PLANNING PROPOSAL

**Proposed amendment to Port Stephens
Local Environmental Plan 2013:**

Proposal to amend the Land Zoning Map,
Minimum Lot Size Map, and Building Height Map
Lot 1 D.P.1019113, No. 98 Coachwood Drive, Medowie

Clarification of Referral Responses received from PSC Facilities and Services Group

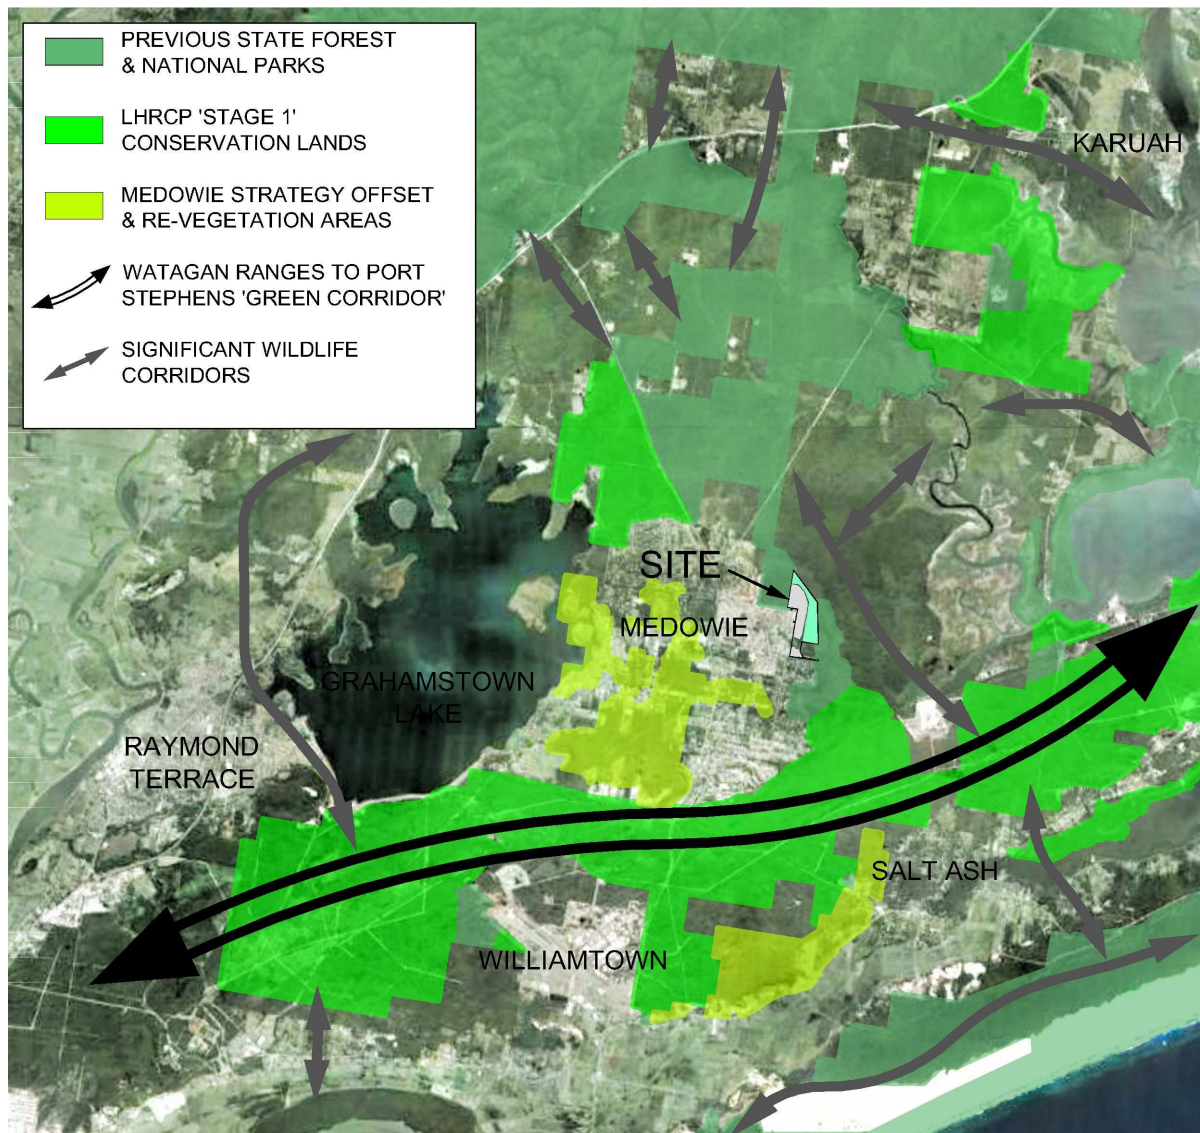
- EEC – there is removal of some swamp sclerophyll EEC (also known as preferred koala Habitat), this too has not been offset.

The preliminary Concept Masterplan may require revision to mitigate this occurrence if bio-diversity offset arrangements are not considered appropriate.
